Team Update II (it's one louder)

Team Update 10

Figure 7-3: Don't touch opponents' ROPES in the final thirty (30) seconds of the MATCH.

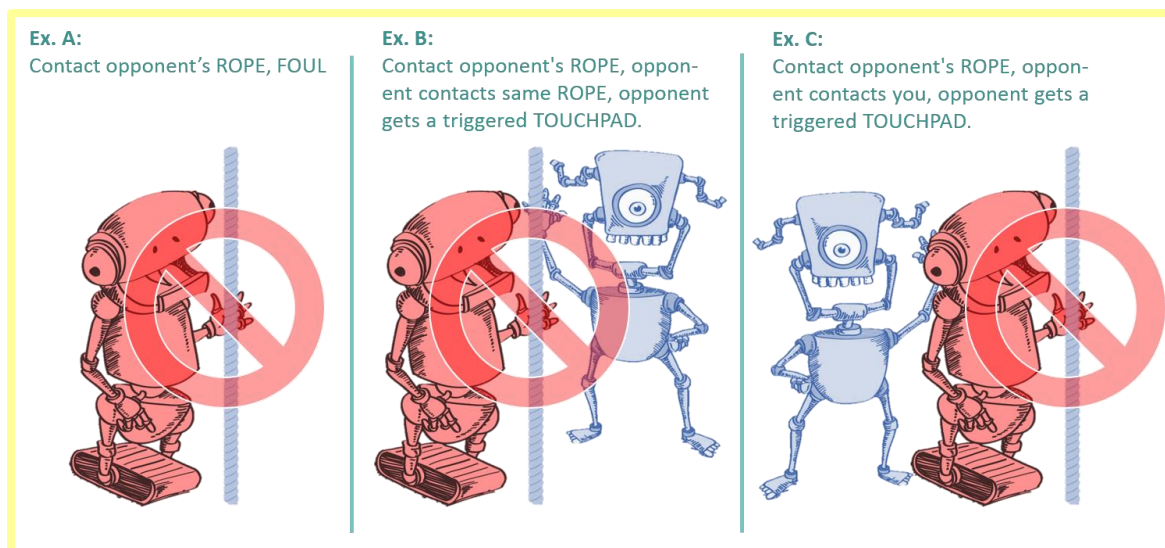
- G20. Let 'em climb: don't touch their ROPES.** During the final thirty (30) seconds of a MATCH, ROBOTS may not contact an opposing ALLIANCE'S ROPE.

Figure 2-1: FIRST STEAMWORKS playing area

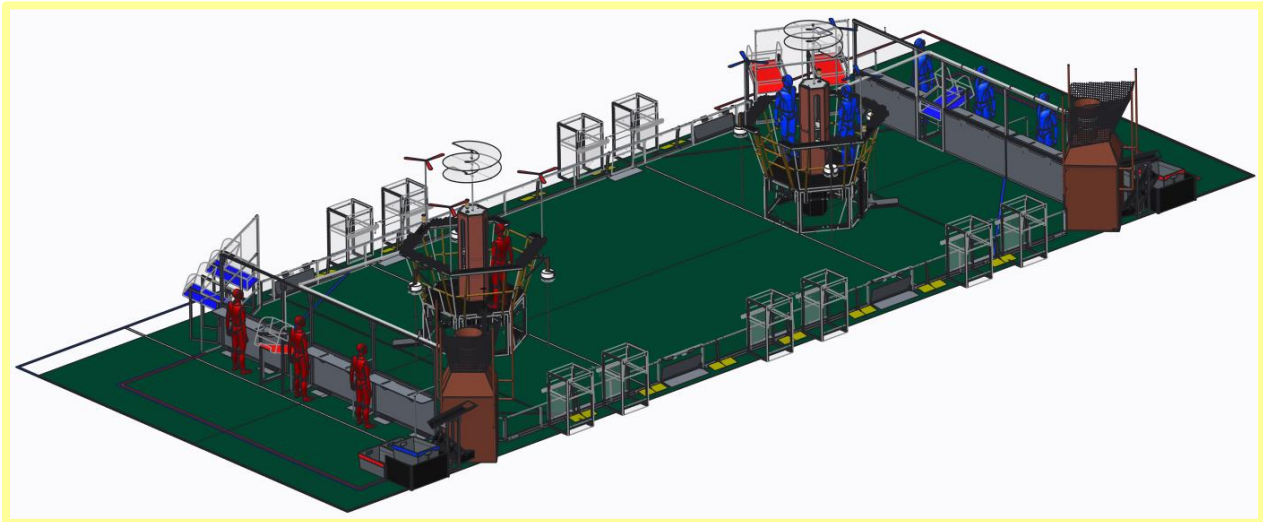
Figure 2-1, a still from the [2017 FIRST STEAMWORKS game animation](#), has been replaced with an export from the official CAD model of the FIRST STEAMWORKS playing area per the first bullet in General Notes above.

Figure 3-20 Unactuated TOUCHPAD (left) and fully displaced TOUCHPAD plate (right)

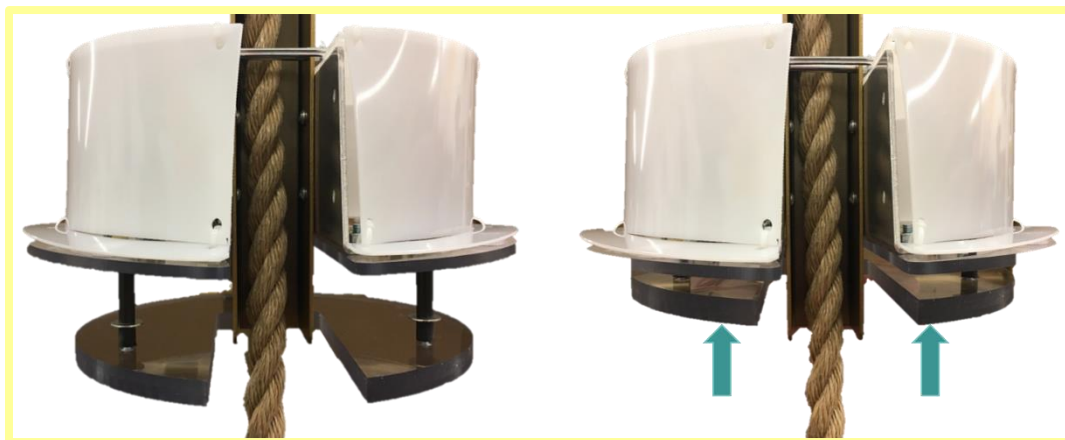
Figure 3-20 shows the two extreme states of the TOUCHPAD plate. The image on the left shows the TOUCHPAD unactuated and the figure on the right shows one example of an actuated TOUCHPAD (with the plate pressed all the way up). The DAVIT'S steel channel does not move with the TOUCHPAD plate.

Figure 9-2 ROPE anatomy

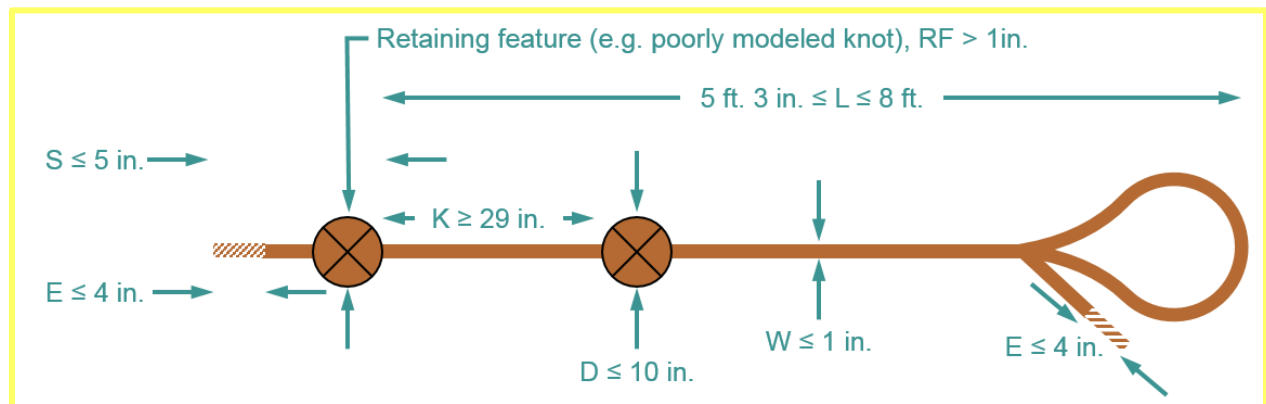
I04. ROPES have to be inspected. A Team must submit any ROPE they intend to use in a MATCH for Inspection. A ROPE must meet the following criteria (see Figure 9-2 for letter references):

- B. be designed/configured to be at least 5 ft. 3 in. (~160 cm) long (~~measured end to end~~) measured from the side of the ROPE'S retaining feature (per I04-E) that abuts the DAVIT fingers (L), to the farthest point on the ROPE from this feature.
- C. be designed/configured to not exceed a length of 8 ft. (~244 cm) (~~measured end to end~~) measured from the side of the ROPE'S retaining feature (per I04-E) that abuts the DAVIT fingers (L), to the farthest point on the ROPE from this feature.
- D. consist entirely of flexible, non-metallic fibers twisted, tied, woven, or braided together except for the last 4 in. (~10 cm) of ~~each~~ any cut end (E) which may be whipped, (with material that is flexible and non-metallic) or fused, ~~covered in heat shrink or tape, or dipped in a coating material only~~ to prevent fraying.

- F. if knotted, the top knot must be at least 29 in. (~74 cm) below the retaining knot/feature (K)
- G. if knotted or looped, the total diameter does not exceed 10 in. (~25 cm) (D)

- H. be designed/configured to not exceed a length of 5 in. (~12 cm) measured from the side of the ROPE'S retaining feature (per I04-E) that abuts the DAVIT fingers, to the closest end on the ROPE from this feature (S).

Figure 3-7: AIRSHIP elements

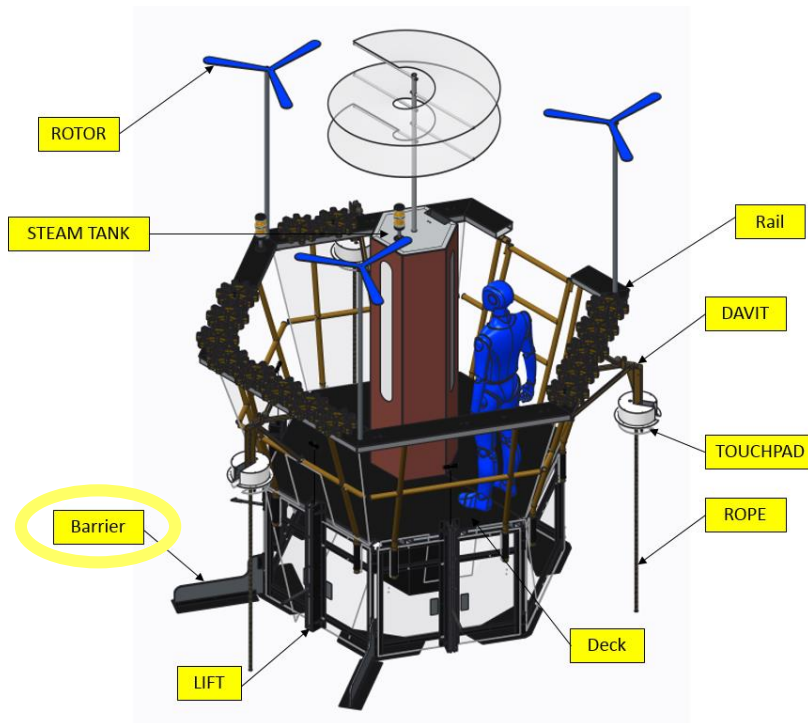
Figure 3-7: “Divider” label has been changed to “Barrier” to match text in Section 3.5 LIFTS.

Figure 3-24: ALLIANCE WALL COMPONENTS

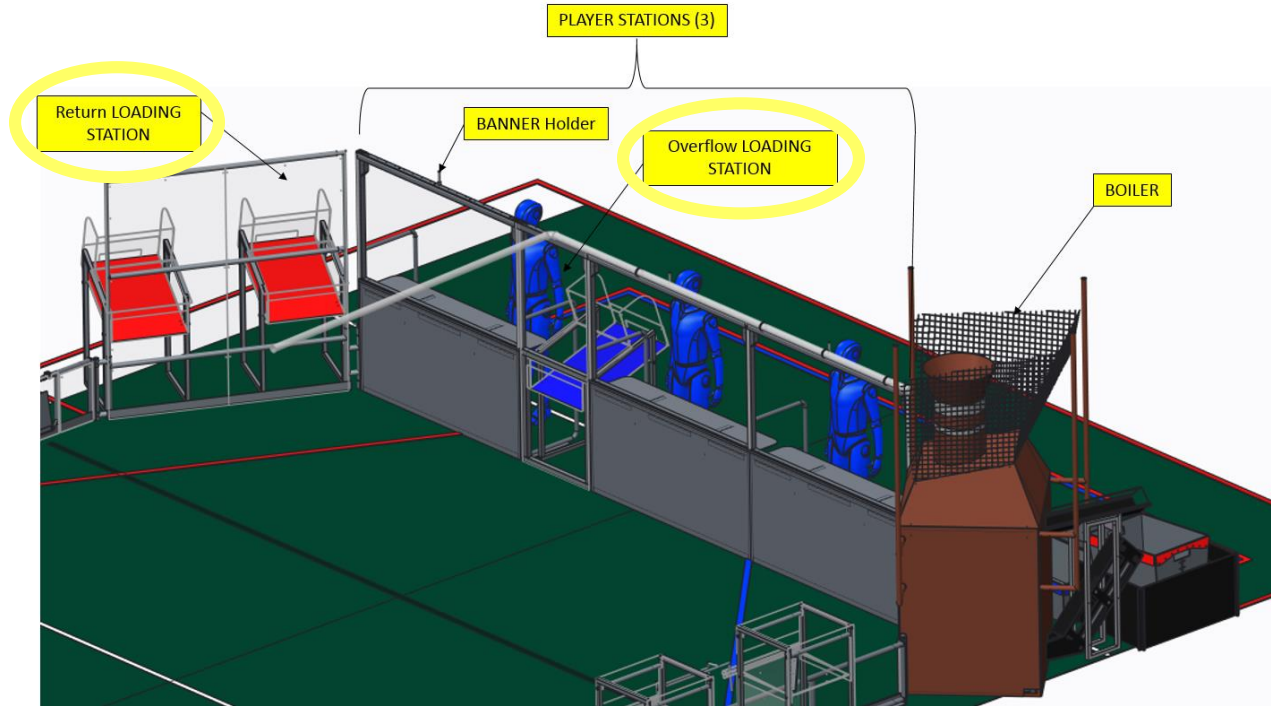
Figure 3-24: The labels for the OVERFLOW and RETURN LOADING STATIONS have been corrected.
